**Subject: Docket No. 50-361
Report Of Inservice Inspection Of Steam Generator Tubes,
Cycle 13 Additional Information
San Onofre Nuclear Generating Station, Unit 2**

**Reference: Letter from D. E. Nunn (SCE) to Document Control Desk dated March 17,
2004, Subject: Special Report: Inservice Inspection of Steam Generator Tubes,
Cycle 13**

In order for the staff to complete its review, the following information is requested:

Appendix 2 -- San Onofre Unit 2 Steam Generator E-088 Indications Within the Tubesheet in 2004

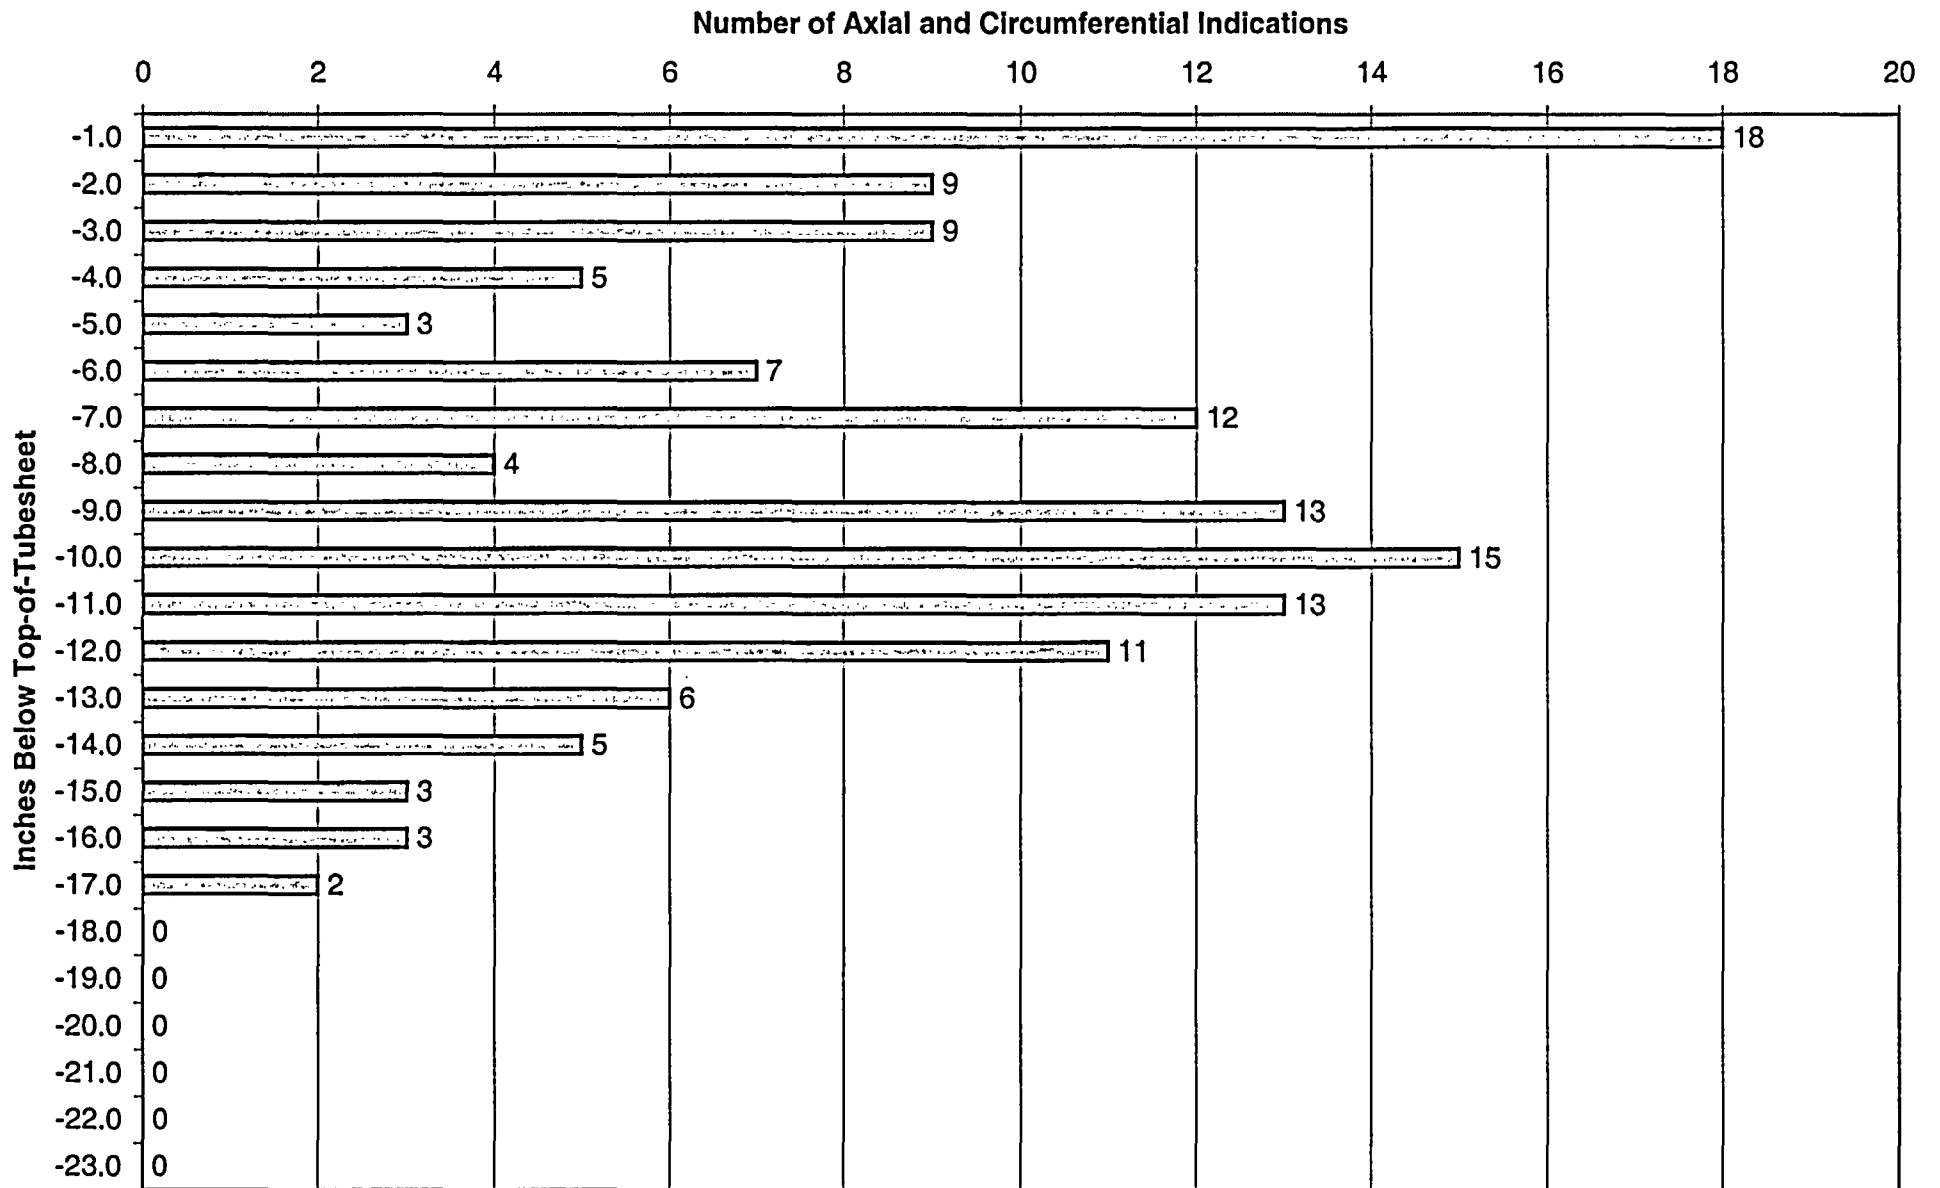
- 3. During conference calls with the staff in March 2004 (ML040910379), the licensee described how the number and depth of indications varied with distance below the top of the tubesheet. For each steam generator, as a function of distance below the top of the tubesheet, please provide the number of indications of each type (i.e. axial/circumferential, outside diameter/inside diameter) and an estimate of the size (length, depth). Please use several depth intervals, including 5" and 17" below the TTS as two of the boundaries between depth intervals, since these were the lower limits of the rotating probe inspections in 2002 and 2004, respectively.**

SCE Response: Appendices 1 through 4 provide the requested information in the requested format. The vast majority of this information was previously provided in Appendices 3 and 4 of SCE's March 17, 2004 letter.

Appendices 1 and 3 are an extraction and re-arrangement of that information, with the addition of some size measurements. Appendices 2 and 4 are graphic aids for Appendices 1 and 3 respectively.

The size measurements that are provided are those that may have relevance, consistent with EPRI guidance. EPRI provides guidance on indication voltage thresholds for which sizing measurements are relevant for tubing integrity purposes. This guidance is in EPRI's "Steam Generator In Situ Pressure Test Guidelines, Revision 2", Report Number 1007904, dated August 2003.
